Chapter 3

Items 3-1-12 through 3-31-12

June 14, 2013.

**Ballot Comment and Proponent Comment Agenda- July 15-19, 2013:
Proposals of 2012 submitted on the ICC A117.1-2009**

Figure 304.3(a)
SIZE OF TURNING SPACE

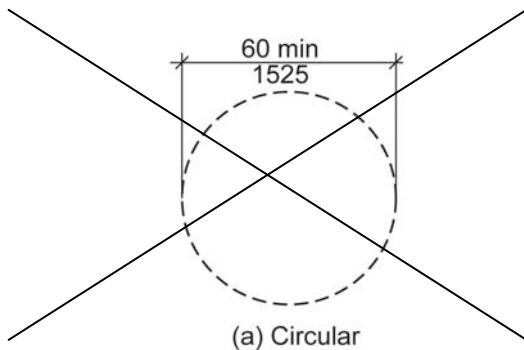
304.3.1 Circular Space. The turning space shall be a circular space with a ~~60-inch~~ 67-inch (1525 1700 mm) minimum diameter. The turning space shall be permitted to include knee and toe clearance complying with Section 306.3.

Proposal 3-9 Excpt. 1

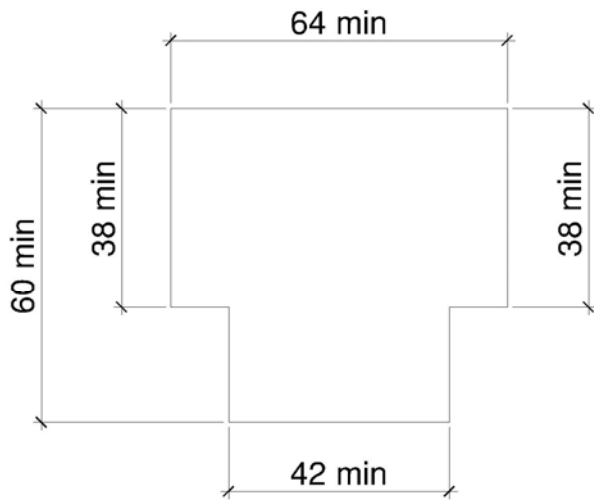
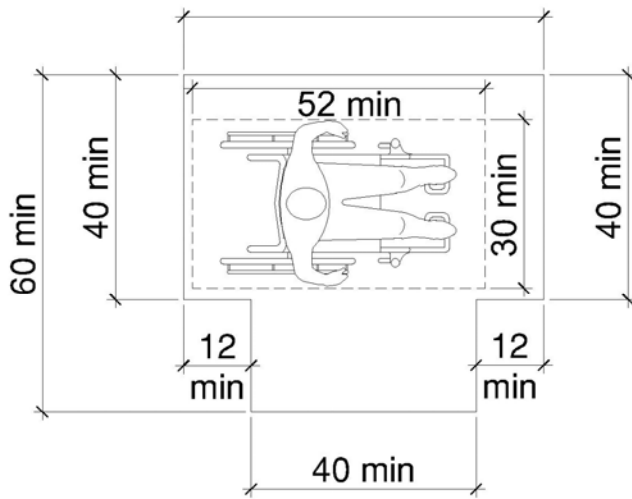
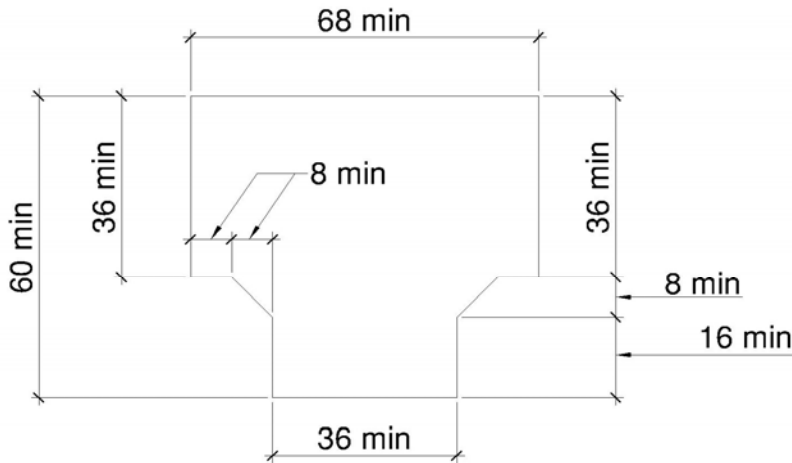
Modification *Text not prepared. Need the text to reflect the 3 diagrams*

Committee Reason: The Committee explored the various options and limitations for regarding making the T-shaped turn. While the dimensions shown in the figure labeled Proposal 3-9 were the base of the discussions, the Committee concluded that the 3 designs should be shown in the text (perhaps in a table) as 3 equal options for design the space. The Committee approved the figures; asked staff to develop text.

FIG. 304.3
SIZE OF TURNING SPACE

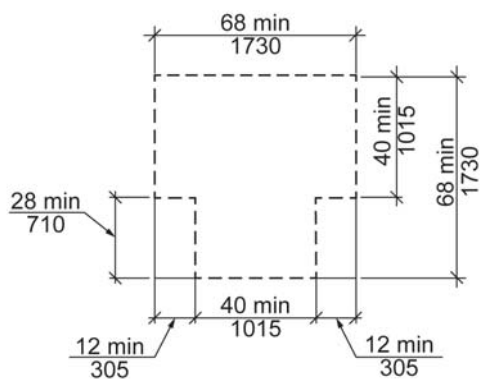
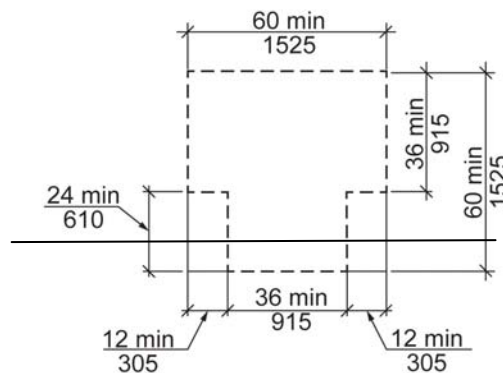
1. Where the arms of the T-shaped space are 42 inches (1065 mm) minimum in width, the base of the T shall be permitted to be 38 inches (965 mm) minimum in width, with the arms of the T clear of obstructions 15 inches (380 mm) minimum in each direction.
2. Where the arms of the T-shaped space are 44 inches (1115 mm) minimum in width, the base of the T shall be permitted to be 36 inches (915 mm) minimum in width, with the arms of the T clear of obstructions 16 inches (405 mm) minimum in each direction.

FIG. 306.2
TOE CLEARANCE

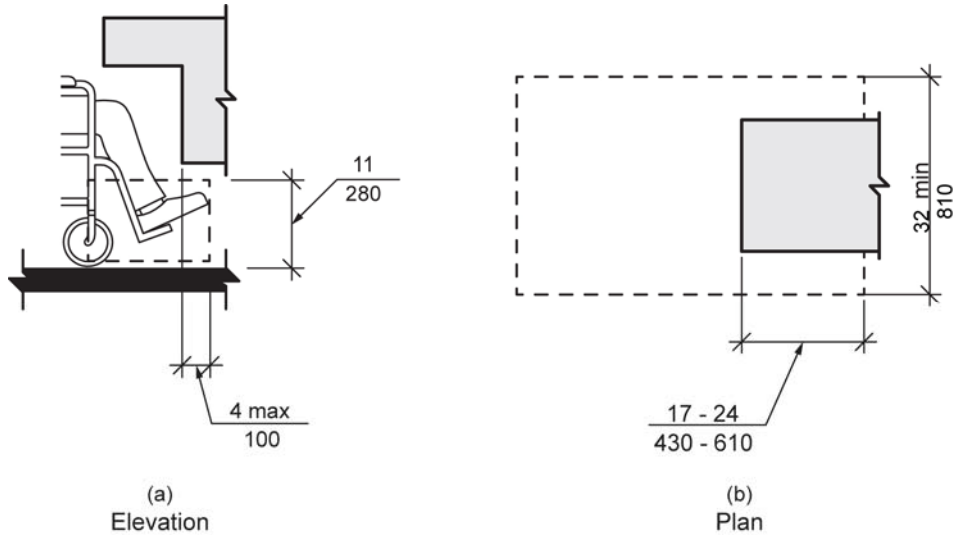
306.3.2 Maximum Depth. Knee clearance shall be permitted to extend ~~25~~ 24 inches (~~635~~ 610 mm) maximum under an element at ~~9~~ 11 inches (~~230~~ 280 mm) above the floor.

306.3.3 Minimum Depth. Where knee clearance is required beneath an element as part of a clear floor space complying with Section 305, the knee clearance shall be ~~44~~ 13 inches (~~280~~ 330 mm) minimum in depth at ~~9~~ 11 inches (~~230~~ 280 mm) above the floor, and ~~8~~ 11 inches (~~205~~ 280 mm) minimum in depth at ~~27~~ 29 inches (~~685~~ 735 mm) above the floor.

NOTE: This change necessitates a change to Fig. 306.2 and Fig. 306.3 to ensure consistency. Thus, the proposed revised figures have been attached, along with the existing figures for comparison purposes.

FIG. 306.3
KNEE CLEARANCE

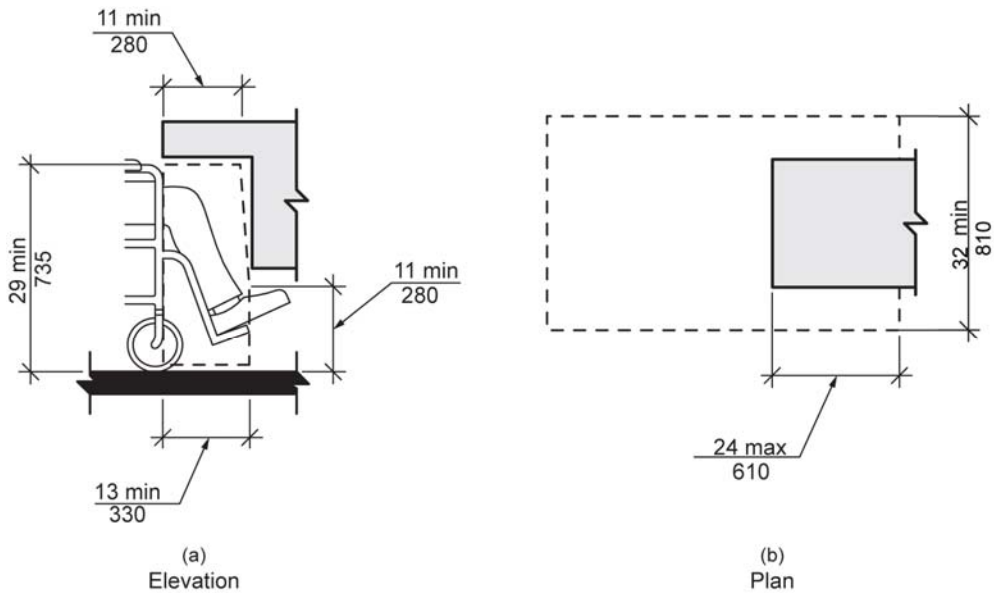
306.3.4 Clearance Reduction. Between ~~9~~ 11 inches (~~230~~ 280 mm) and ~~27~~ 29 inches (~~685~~ 735 mm) above the floor, the knee clearance shall be permitted to be reduced at a rate of 1 inch (25 mm) in depth for each ~~6~~ 9 inches (~~150~~ 230 mm) in height.

306.3.5 Width. Knee clearance shall be ~~30~~ 32 inches (~~760~~ 810 mm) minimum in width.

308.2.1, Figure 308.2.1

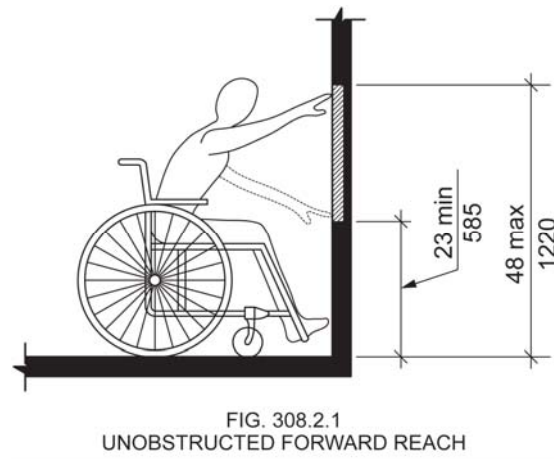
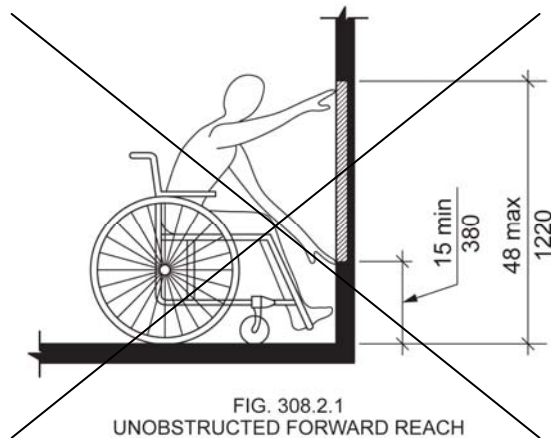
- 1) A substantial number of wheeled mobility users (about 15% of manual chair users and 42% of power chair users) did not possess any functional reach capability (defined as reaching and placing an empty canister above shoulder height), and
- 2) Of the remaining wheeled mobility users in our study that could perform the reach tests a large percentage could not reach beyond the most forward point of their device or foot. These percentages vary at different heights from the floor, and are also different for manual and power chair users. Figure 3-15 (pg. 68) in the Anthropometry of Wheeled Mobility (AWM) report (Steinfeld et al., 2010) summarizes these findings.

NOTE 2: This change necessitates a revision to Fig. 308.2.1 to ensure consistency. A revised figure is attached.

FIG. 308.3.1
UNOBSTRUCTED SIDE REACH

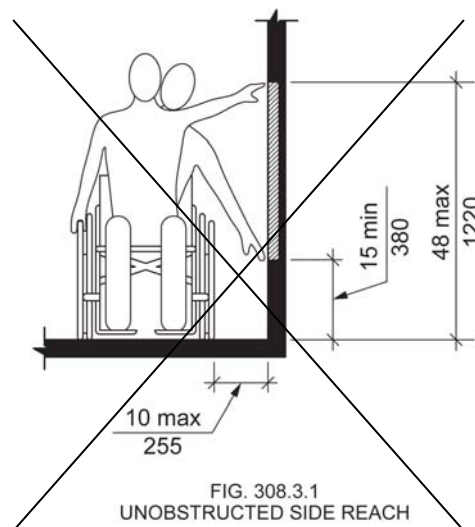
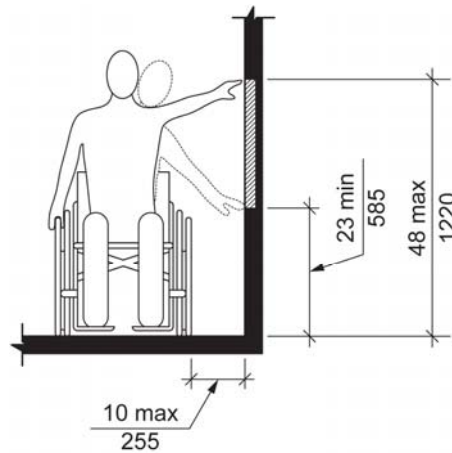
308.3.1 Unobstructed. Where a clear floor space complying with Section 305 allows a parallel approach to an element and the edge of the clear floor space is 10 inches (255 mm) maximum from the element, the high side reach shall be 48 inches (1220 mm) maximum and the low side reach shall be ~~45~~ 23 inches (~~380~~ 585 mm) minimum above the floor.

NOTE 2: This change necessitates a revision to Fig. 308.3.1 to ensure consistency. A revised figure is attached.

**Fig. 308.3.1
Unobstructed Side Reach**

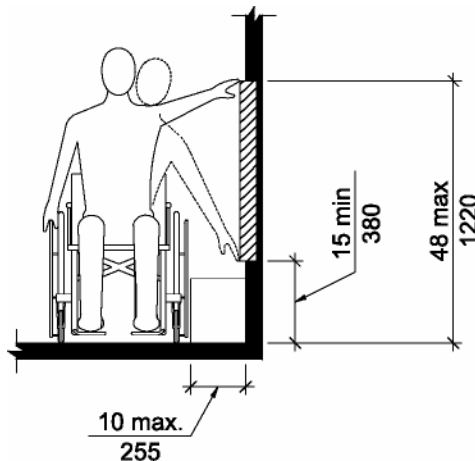
1. Existing elements that are not altered shall be permitted at 54 inches (1370 mm) maximum above the floor.
2. Where an unobstructed side reach is available, thermostats in Type B dwelling and sleeping units shall be permitted at 54 inches.

Reason: Forty eight inches is too low for people not in wheel chairs. This would match UFAS 4.2.6.
